**CITY OF LOMPOC  
PLANNING COMMISSION STAFF REPORT**

**MEETING DATE:** NOVEMBER 13, 2006  
**TO:** MEMBERS OF THE PLANNING COMMISSION  
**FROM:** KEITH C. NEUBERT, ASSOCIATE PLANNER  
**RE:** ZONE CHANGE – ZC 06-06 / TENTATIVE  
SUBDIVISION MAP – LOM 558 /  
PRELIMINARY/ PRECISE DEVELOPMENT  
PLAN – DR 05-43

**AGENDA ITEM NO. 1**

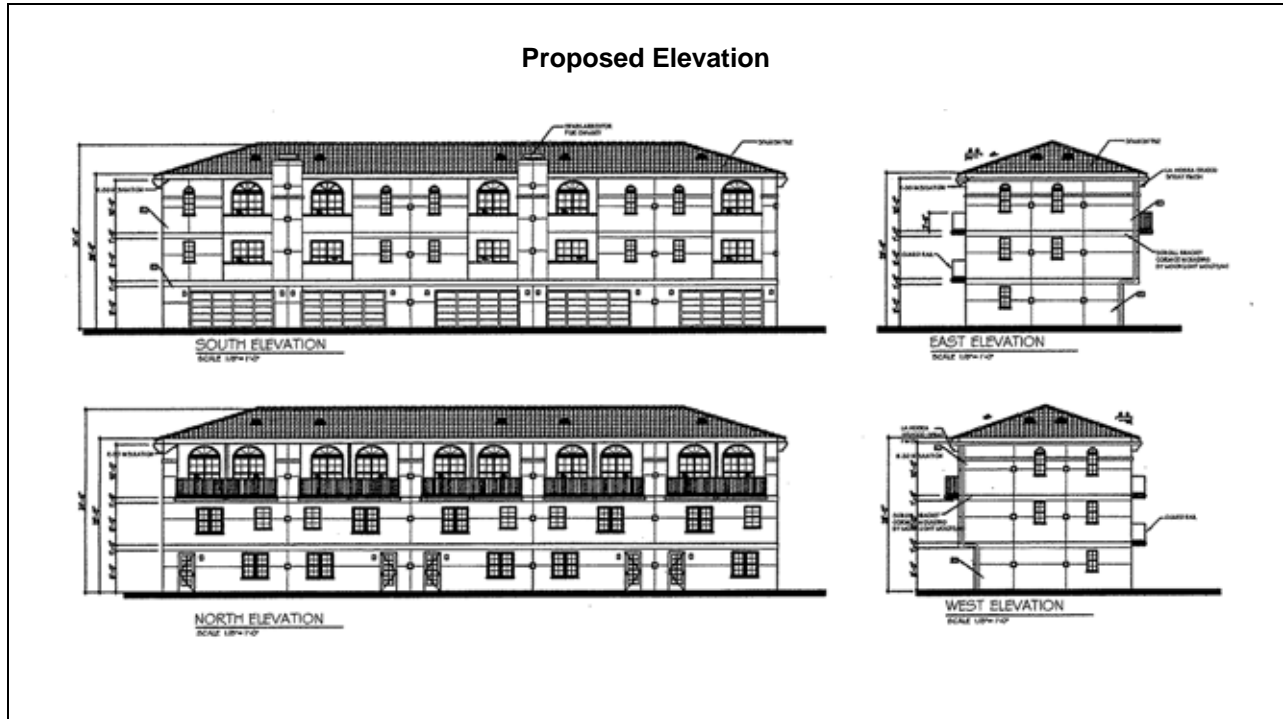
The front and rear elevations provide sufficient architectural detail to meet the City's architectural Review Guidelines. The side elevations, however, provide very little architectural detail and will be highly visible from the street. A Condition of Approval is included requiring additional architectural detail on the side elevations. The changes shall be reviewed by staff at plan check and approved, if appropriate (DR COA P61).
